# EXPLANATION OF SIGNIFICANT DIFFERENCES (ESD)

**RE-SOLVE, INC. SUPERFUND SITE**
**MANAGEMENT OF MIGRATION**
**OPERABLE UNIT 3**

**NORTH DARTMOUTH, MASSACHUSETTS**

**September 2015**

**Re-Solve Inc. Superfund Site, MOM, OU3**

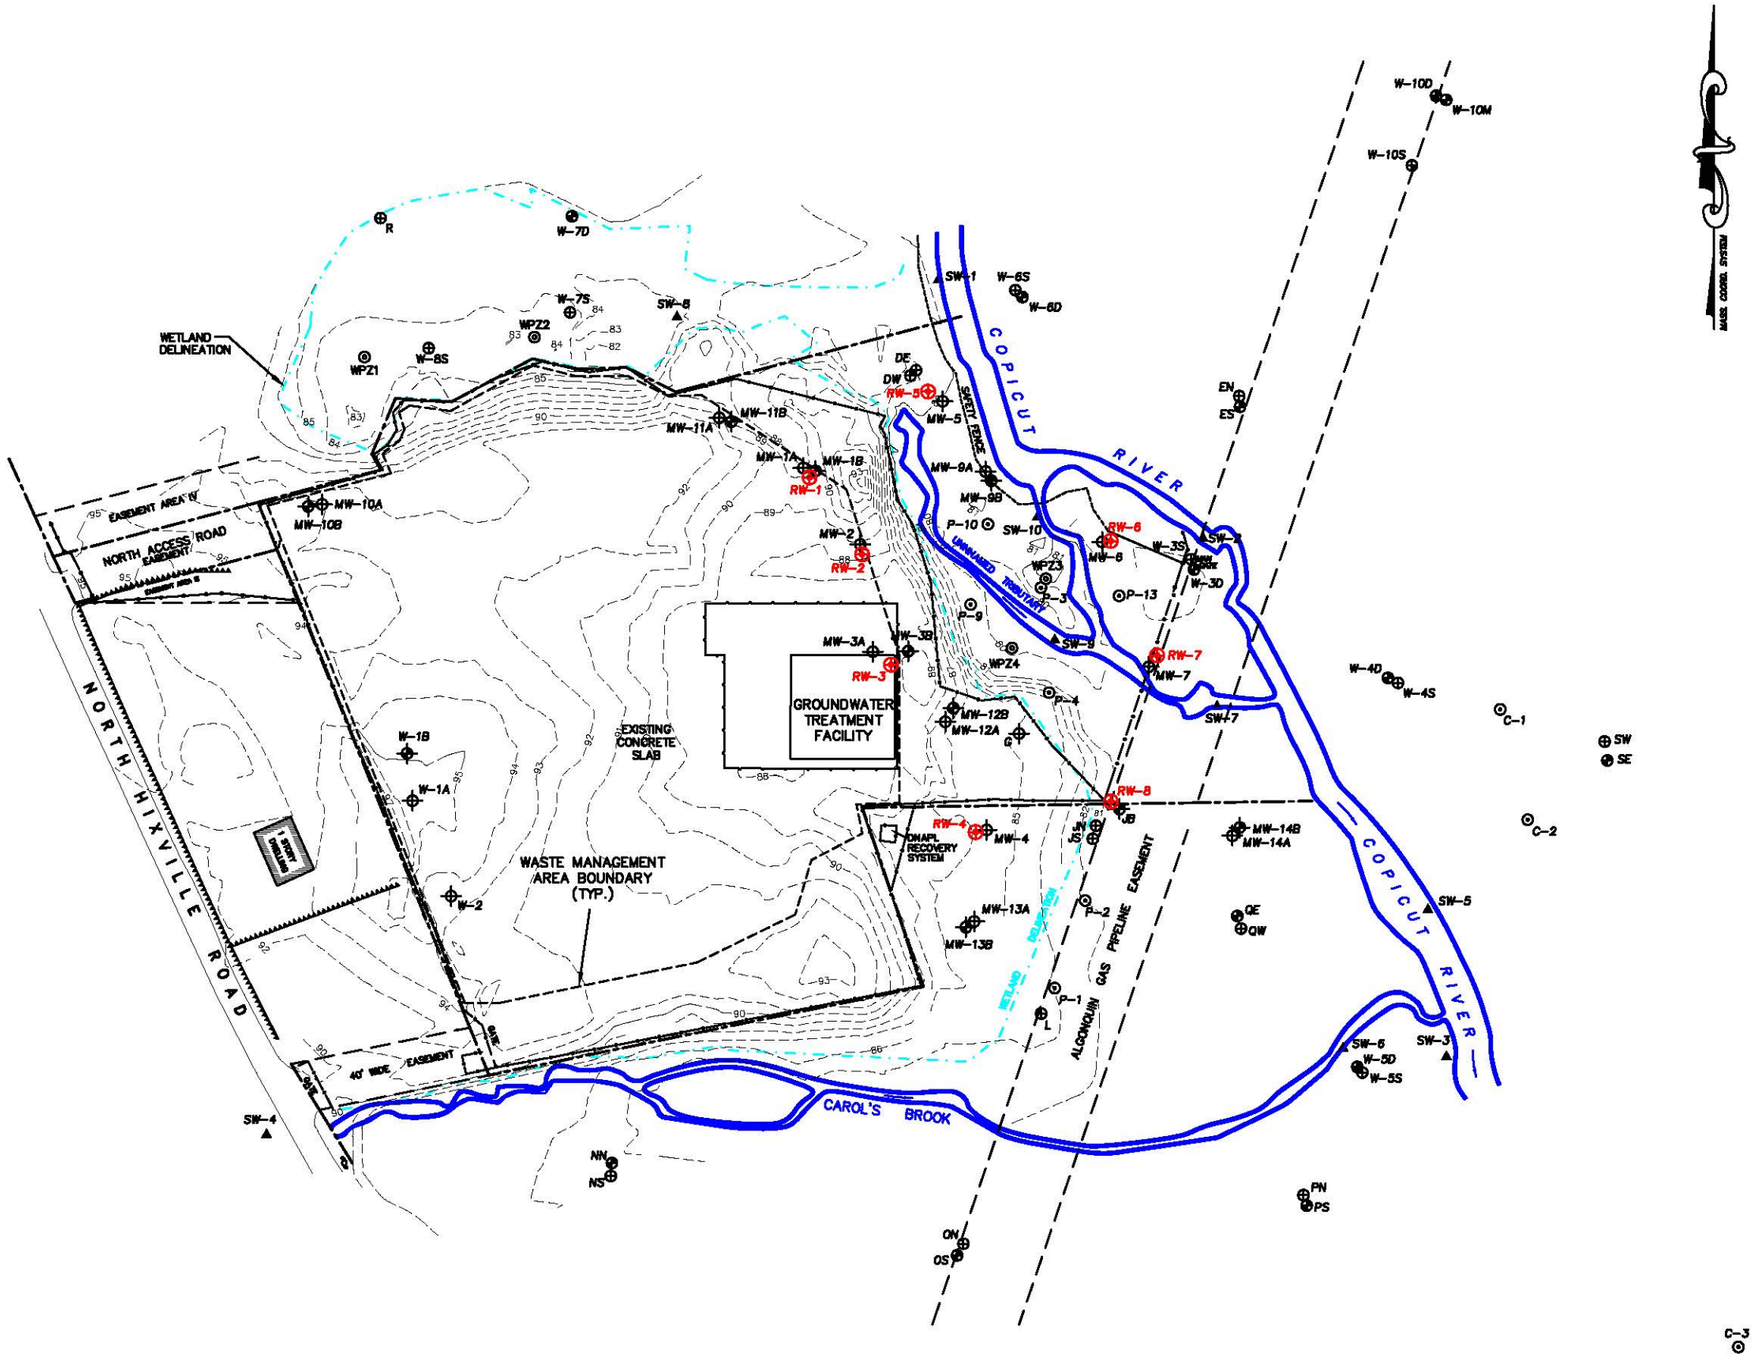
In 1996, the Management of Migration Remedial Design Implementation Plan (1996 MOM Implementation Plan (100% Remedial Design)) was completed, documenting the details for a pump and treatment system. The flushing aspect of the MOM component of the remedy was eliminated during the MOM Remedial Design process, as groundwater modeling simulations indicated that the inclusion of reinjection wells might pose a risk of remobilizing dense non-aqueous phase liquid (DNAPL) and a reevaluation for the need for soil flushing indicated that inclusion of reinjection wells would not offer significant improvements in plume capture or cleanup times. Additionally, it was determined that the bulk of contaminated soils above the seasonal groundwater low (SGL) level was excavated and treated during the Source Control component (OU2) of the remedy, further mitigating the need for flushing (1994 Intermediate (60%) Design Report, Management of Migration (60% Remedial Design), pp. 4-5 – 4-6). Therefore, all treated groundwater is discharged to surface water (i.e. Copicut River) on-site, in compliance with the substantive requirements of the Clean Water Act National Pollutant Discharge Elimination System (NPDES) regulations. In 1999, EPA documented the successful construction and operations of the MOM pump and treatment system in the Final Remedial Action Report - Management of Migration Remedial Action (1999 MOM Remedial Action Report). See Figure 2 for location of MOM Extraction and Monitoring Wells.

The 1987 ROD selected MOM target cleanup levels for certain contaminants of concern outside the boundary of the waste management area (see Figure 2 for approximate location of waste management area) based upon the Safe Drinking Water Act's Maximum Contaminant Levels (MCLs) or risk assessment:

**Re-Solve Inc. MOM Treatment: Comparison of Original and ABR Enhancement**

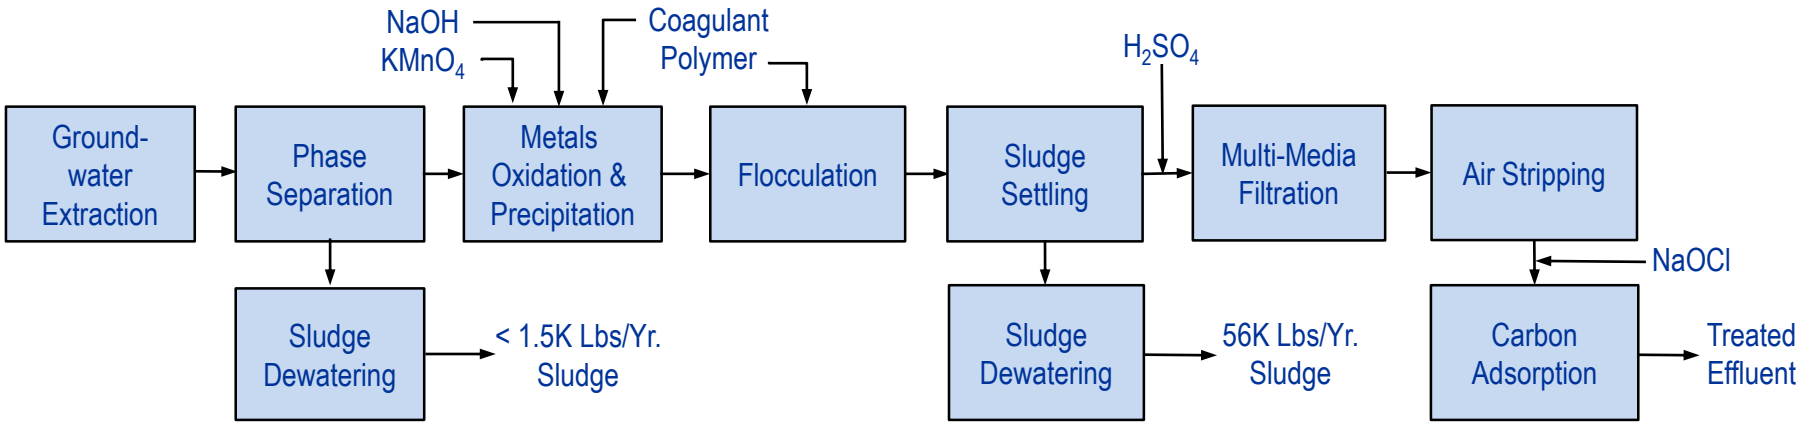
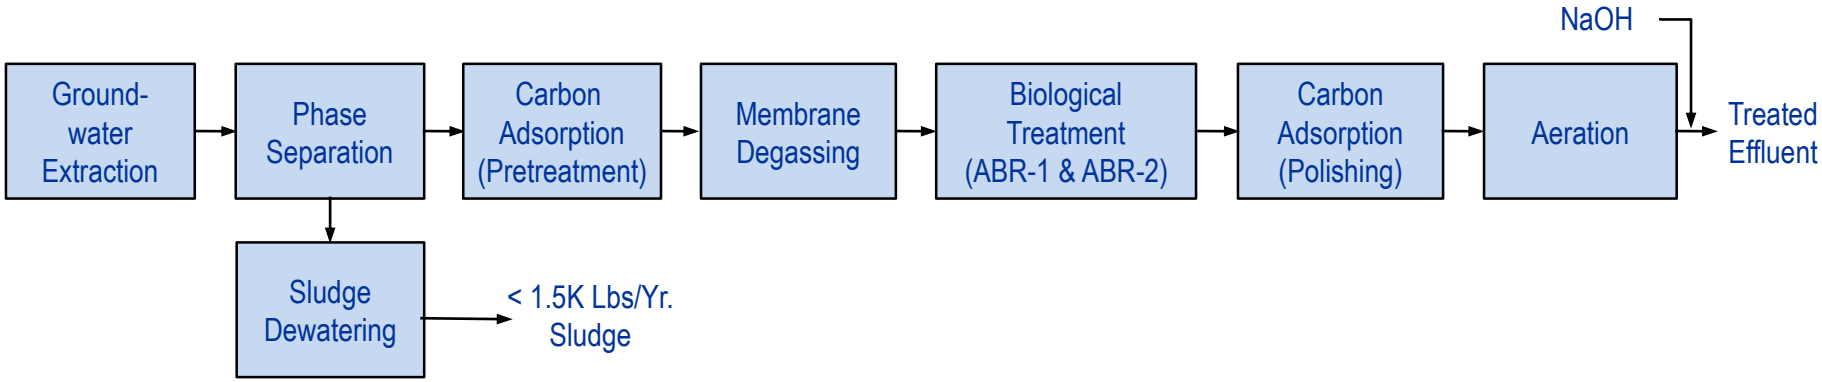
In May 2011, EPA agreed to allow the construction and monitoring of a full scale pilot ABR Sustainability Enhancement Design and associated Photovoltaic Design. In July 2014, the ReSolve Site Group submitted a MOM Sustainability Enhancement Performance Report documenting successful operations and monitoring of the ABR Sustainability Enhancement Design and Photovoltaic Design as a modification to the original MOM design, and the achievement of surface water discharge standards. The ABR Sustainability Enhancement Design significantly reduces contaminants through the GAC and ABR treatment beds, and does not require an air stripper.

- The anoxic influent from the eight extraction wells is processed through the phase separator and influent tank, where solids are drained to the sludge holding tank and dewatered (component of original groundwater treatment system).

- The low dissolved oxygen levels are maintained throughout the system until aeration and discharge.
- The process water is pumped from the influent tank to the two 10,000-pound pre-treatment carbon vessels (components of original groundwater treatment system) to primarily remove PCBs.

- The process water flows through a degassing membrane system to reduce total dissolved gasses before entering the ABR 1 and 2 beds. The ABR 1 and 2 beds are two self-contained, subsurface beds filled with a sand-peat media designed to anaerobically degrade VOCs in the process water (via reductive dechlorination process). During months when the groundwater influent from the extraction wells are coldest, heat is applied to the process water before entering the ABR beds for maintaining healthy anaerobic conditions.

- The process water then travels through two 5,000-pound polishing carbon vessels to provide further assurance of compliance with the discharge limits in the event of a system upset.
- Final aeration steps/columns and pH adjustments achieve appropriate surface water dissolve oxygen and pH levels for surface water discharge.

A comparison of the original MOM treatment system to the ABR enhancement is presented in Figure 3.
